Reviewer 2

The concept of a new method for measuring actinic flux is a worthwhile cause, however this work indicates that more effort is needed.

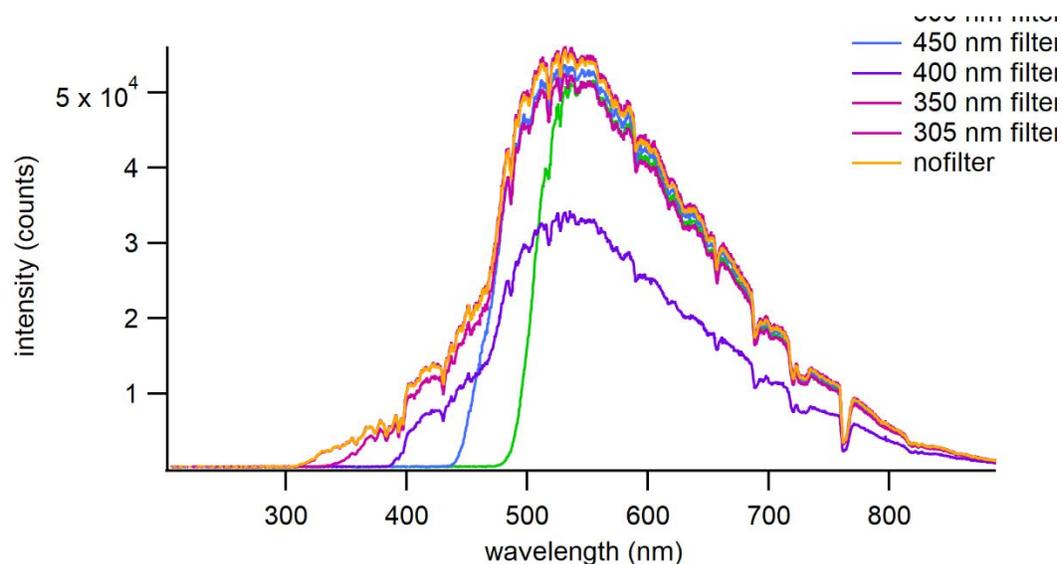
Line 137 – The results of the stray light tests should be shown. “Minimal leakage” is not a quantitative term and can strongly influence photolysis rate calculations, particularly for jO_3 .

Line 140 – Quantify “residual stray light” and the associated wavelength dependence

Residual stray light is now quantified using the long-pass filter method. For each filter, the signal recorded below the cut-on wavelength provides a wavelength-resolved upper bound on out-of-band stray-light contributions. The maximum bound in the UV-B region relevant for $\text{j}(\text{O}_3)$ is $<0.16\%$ of the in-band signal after dark correction. Across the tested wavelength range, residual signal below each cut-on wavelength was at or near the detection limit, indicating negligible wavelength-dependent stray-light contamination.

Figure R1 (included in this response) shows the long-pass filter spectra used to derive this bound. When short wavelengths are physically blocked, the remaining UV-B counts fall below 0.16% of the visible signal, demonstrating that scattered longer wavelengths do not significantly contribute to UV-B pixels.
